**NOTICE OF A PUBLIC HEARING BEFORE
THE CITY COUNCIL ON AN APPEAL OF A
PORTLAND DESIGN COMMISSION DECISION**

CASE FILE: LU 12-212602 DZM GW AD, Riverscape Apartments
WHEN: Wednesday June 12th, 2013 @ 3:00 p.m.
WHERE: COUNCIL CHAMBERS, 1221 SW FOURTH AVENUE

RIVERSCAPE APARTMENTS
 APPLICATION FOR TYPE III DESIGN REVIEW
 (Revised) 05 April 2013

To:	Bureau of Development Services; City of Portland, Oregon; and City Council of Portland, Oregon
From:	The Planning Committee of The Community Association of Northwest Portland, Inc. aka The Northwest District Association or the NWDA ("NWDA")
Date:	May 17, 2013
RE:	Appeal of Decision of the Design Commission Rendered on April 18, 2013, Riverscape Apartments (the "Decision") (LU 12-212602 DZM GW AD)

GROUND FLOOR PLANS
 LOTS 09, 10, 11, 12
 09

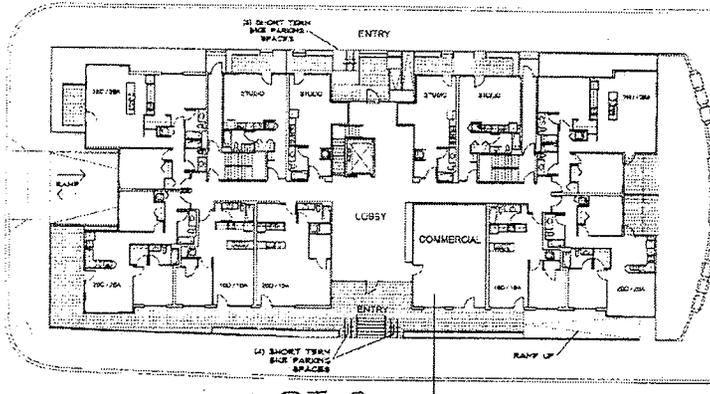
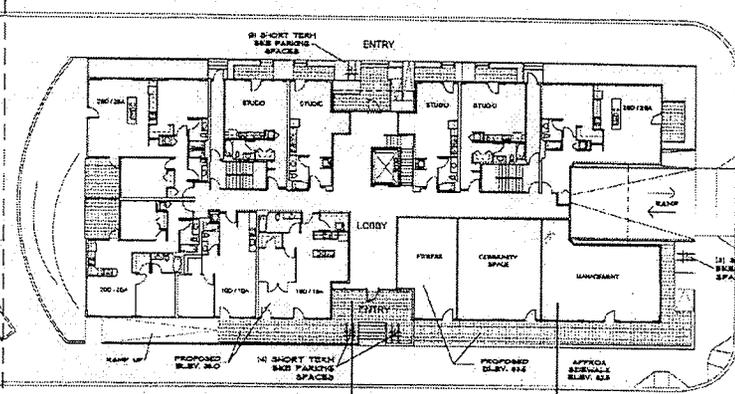
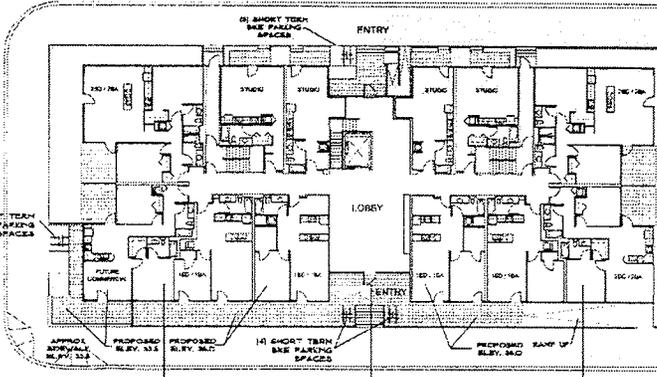
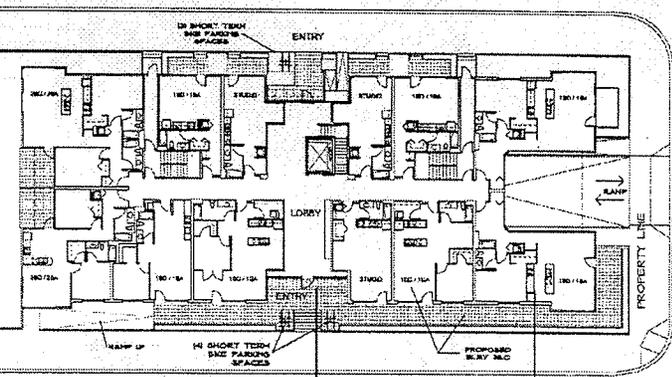
Each face of all of the proposed buildings is set back from either the actual or the "apparent" property lines. This appears to be done to allow for all site grade transitions to occur external to the buildings, but this is done at the expense of the sidewalk environment next to the buildings. This approach creates a suburban response to the ground plane, and a series of awkward relationships between confused public and private realms.

- *ambiguous raised planted areas that are inaccessible;*
- *awkward semi-private residential patios at sidewalk level;*
- *ramps and grade transitions to awkward raised semi-public secondary sidewalks directly adjacent to residential units;*
- *louvered air intakes for below grade parking areas directly adjacent to the public sidewalk;*
- *curb cuts and access ramps to subgrade parking.*

The arrangement of the "courtyards" in the mid-block easements does not respond to adjacent ground floor program uses, nor does it create relationships to the aligned passages across Riverscape Street that lead to the river. The spaces do not have building entries or lobbies oriented to them, and the apartments above do not have balconies or more generous windows that overlook the spaces. The design of the courtyards themselves are based on the extensive use of raised planters, which have the effect of creating spaces that lack important flexibility, tend to emphasize peoples' movement through the spaces, and provide little opportunity for the most typical uses of this sort of public space: sitting, reading and interacting with your neighbors. Therefore, this guideline is not met.

POSSIBLE SOLUTION: These buildings need to reinforce the pattern of 60' street enclosures on at least 16th, 17th, 18th Avenues and Riverscape Street, and at the easements mid-block, with possibly some variation at Front Avenue to allow for its more public boulevard character. The site north to south grade differential needs to be accommodated through grade transitions on the interior of the ground floors of the buildings. The buildings need to mostly abut to the property lines, so as to reinforce the site context and to diminish the suburban feel of the exterior grade transitions, the raised planting beds, and the raised semi-private sidewalks referred to as "loading docks."

- *floor levels at ground floor residential units should be 3'-4' above the public sidewalk grade, but not with common accessways, or "loading docks"; and*
- *floor levels at ground floor commercial lease areas and at live/work units should be at the public sidewalk grade.*

POSSIBLE SOLUTION: Arrange these courtyards to respond to and reinforce the adjacent site context.

PERSPECTIVE
NW FRONT AVENUE
16

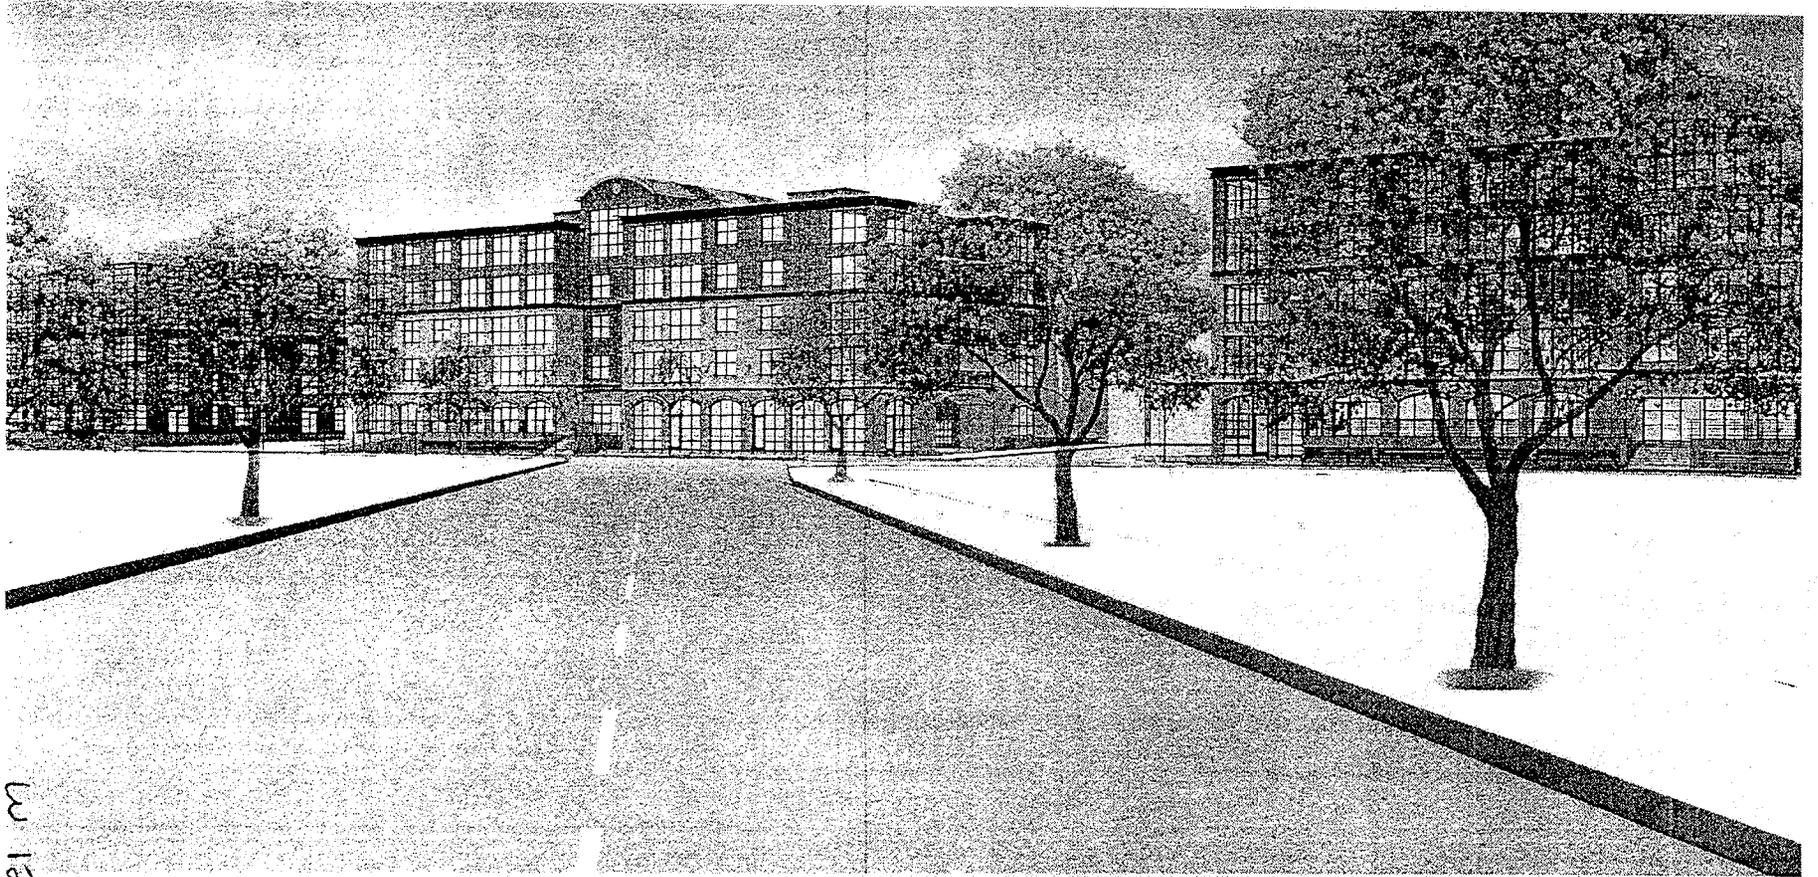
The proposal does not recognize nor respond to, either in the design of the buildings or the site, its location one block away from the river and the developed public amenities at the river's greenway improvements.

- *The building footprint is unresponsive to the Willamette River context and more in keeping with the geometry of the blocks. While both need to guide the architecture, in this case only one is utilized. The building footprint and massing make no attempt to take advantage of their river view location.*

- *The location of outdoor balcony spaces are at the ends of the buildings without any orientation to the river amenity.*
- *There is no focal point to these buildings that suggests they are within a block of the river. In essence these building could be anywhere in the Pearl District, on North Williams or even in the Gateway District.*

- *The uniformity of the massing is not oriented to the river in any way beyond the parallel placement. Breaks in the individual building facades denoting opportunities to experience a river-side lifestyle are not included.*

- *The project does nothing to celebrate the river beyond retaining three out of the six current visual openings found in the existing Riverscape Townhomes.*

The group of buildings and public spaces do not reflect the specific context and essential character of this one-of-a-kind location. There is little response to its frontage on an industrial boulevard and proximity to the river. They could be as easily derived from many other locations. The "loading docks" are raised semi-private sidewalks that confuse the boundary between public and private areas, and are unsuccessful.

POSSIBLE SOLUTION: Design the building footprints, frontages and facades to respond to and reinforce the river and the adjacent site context. Build to taller heights to take advantage of views to the river. Vary the building ends to allow for windows and balconies to orient to the river, not to each other.

POSSIBLE SOLUTIONS: *Design the building frontages and facades to respond to and reinforce the river and the adjacent site context. Greater height, faceted facades, usable and sizable outdoor balcony spaces on the river facing facade would all indicate that the buildings are oriented toward the waterfront and adjacent parks and trails.*

ELEVATIONS - LOT 11

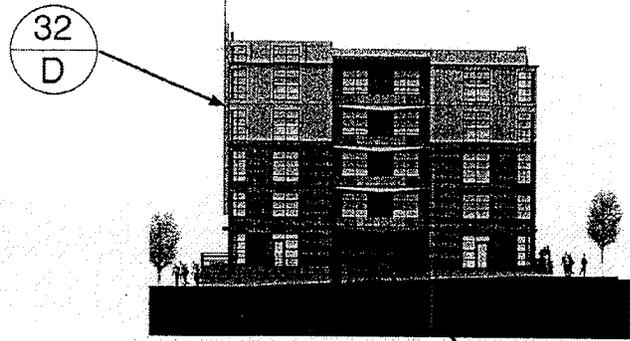
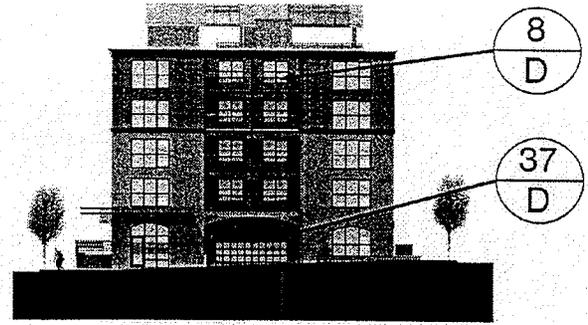
The two pairs of buildings have unrelated and arbitrary material palettes and randomly use nostalgic and contemporary forms and building elements.

The application, extent and transition of exterior façade materials does not appear to be in response to adjacent site characteristics or to varying sun, wind and rain exposures. The buildings use material changes and nostalgic forms, which are arbitrarily, and at times oddly, composed for "graphic effect." The two palette approach is unsuccessful. The building types have subtle differences in their massing and planar composition that would be better served by a single palette of materials.

POSSIBLE SOLUTION: Compose the facades to respond to and reinforce the adjacent site context, and use materials directly and honestly. Vary the footprint, orientation and massing of the buildings to break up the Naito frontage and take advantage of the river and unique rain, wind, glare,
